ADDRESSEES	: ABC-Companies
VEHICLE MODEL	: C2045, T2100 Series, TD925US
SYSTEM/SUBSYSTEM	: Body and body accessories – Exterior parts
BULLETIN TYPE	: Product Improvement
DATE	: April 2, 2012
SUBJECT	: Energy absorbing bumpers – new fasteners
TERMS & CONDITIONS	: Note that no reimbursement will be awarded for carrying out this product improvement.

This Service Bulletin supersedes Van Hool Service Bulletin SB1090 in its entirety.

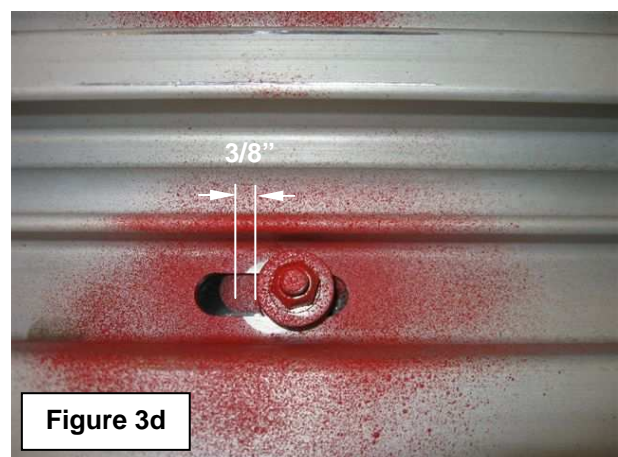
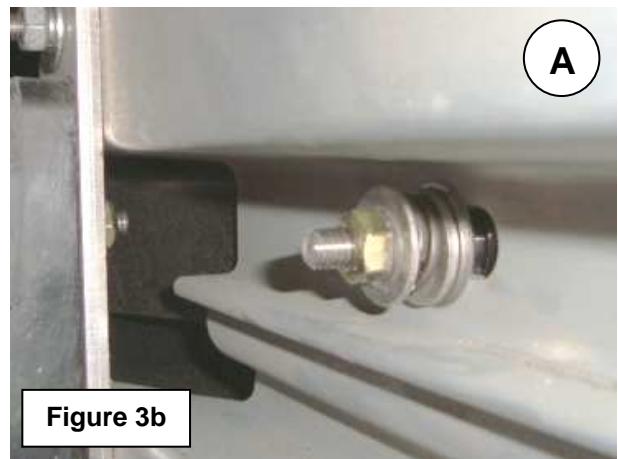
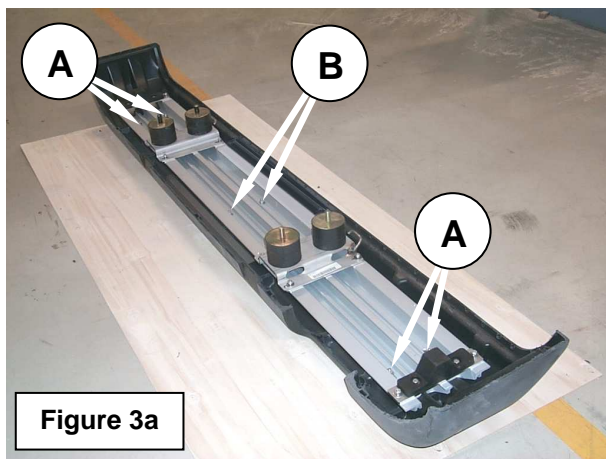
3. With the introduction of energy absorbing bumpers, this issue was addressed as described in Service Bulletin SB1090 by fitment of special washers between the beam and the T-bolt nut. However, further developments have led to the fitment of springs at the extremities of the back-up beam instead of conical washers, and the use of plain washers in the center (Figures 3a, 3b, and 3c).

Tests performed with the assembly heated up to 230°F have shown a shift of 3/8" without deformation of the shell (Figure 3d).

- 1) With the aid of an assistant place the shell onto the back-up beam. Make sure the shouldered bolts of the shell protrude through approximately the center of the slots that have been machined in the beam.
- 2) Install the new fixings for a loose fit on the shouldered bolts in the right order as shown in Figures 3a, 3b and 3c, and Figure 6.

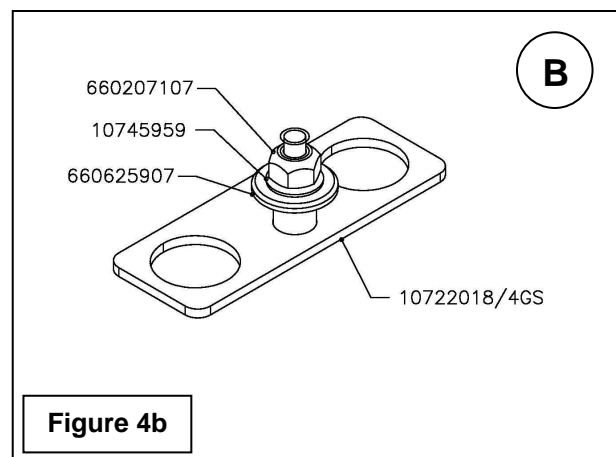
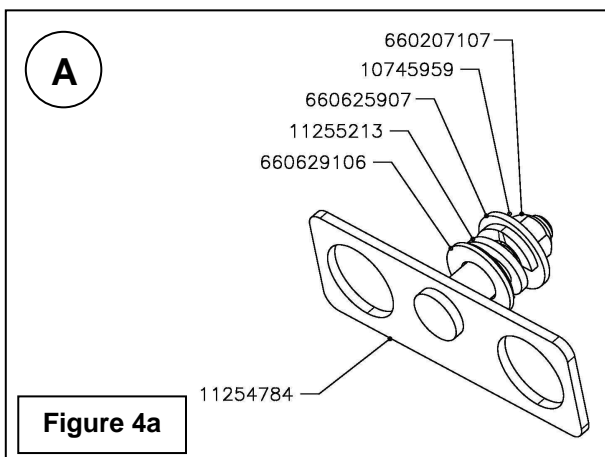
VH reference	Description	Qty.*	Refer to Fig.
660207107	Nut, self-locking, M8, DIN 980	6	4a and 4b
10745959	Washer, disc spring, 16 x 8.2 x 0.9 mm, DIN 2093	6	4a and 4b
660625907	Washer, flat, 8.4 x 25 x 2 mm, DIN 9021	6	4a and 4b
11255213	Washer, double spring, M12	4	4a
660629106	Washer, flat, M12, 13 x 24 x 2.5 mm, DIN 125A	4	4a
11254784	T-bolt shouldered, not available as service replacement	4	4a
10722018	T-bolt shouldered, not available as service replacement	2	4b

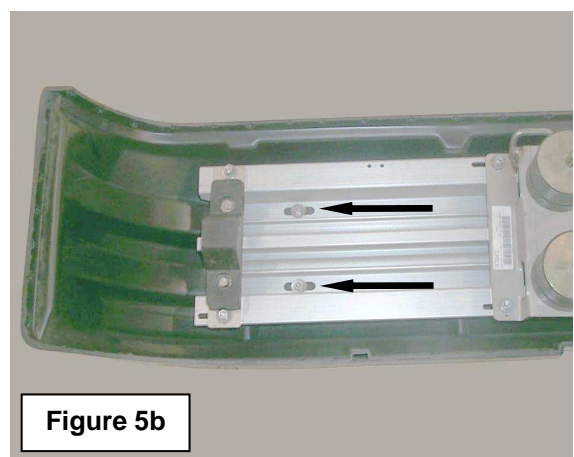
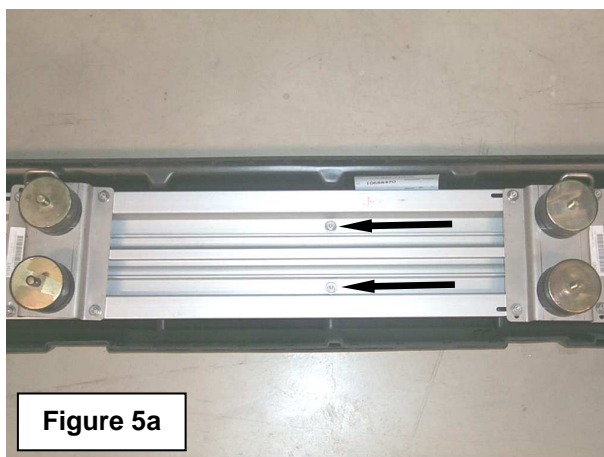
- 1) Open the rear engine compartment door.
Support the bumper on axle stands, or use a hoist and slings to support the assembly.
- 2) In the engine compartment, locate the fixings securing the shell to the back-up beam in the center (Figure 5a) and at the extremities (Figures 5b).
Undo, remove and discard the fixings.

- 3) Adjust the bumper shell position to be flush with the coach side walls and the bumper closing panels.
- 4) Tighten the nuts in the center (Figure 5a) as follows:
 - Run-up the nuts and compress the washers until they can no longer be shifted by hand.
 - Tighten each nut further through 180° (three hex flats).
The disc spring washers are now properly tightened.
- 5) Tighten the nuts at the extremities (Figure 5b) in the same manner.
- 6) Coat all fixings with Loctite 8156 anti-seize lubricant from Henkel.
- 7) Close the engine compartment door.
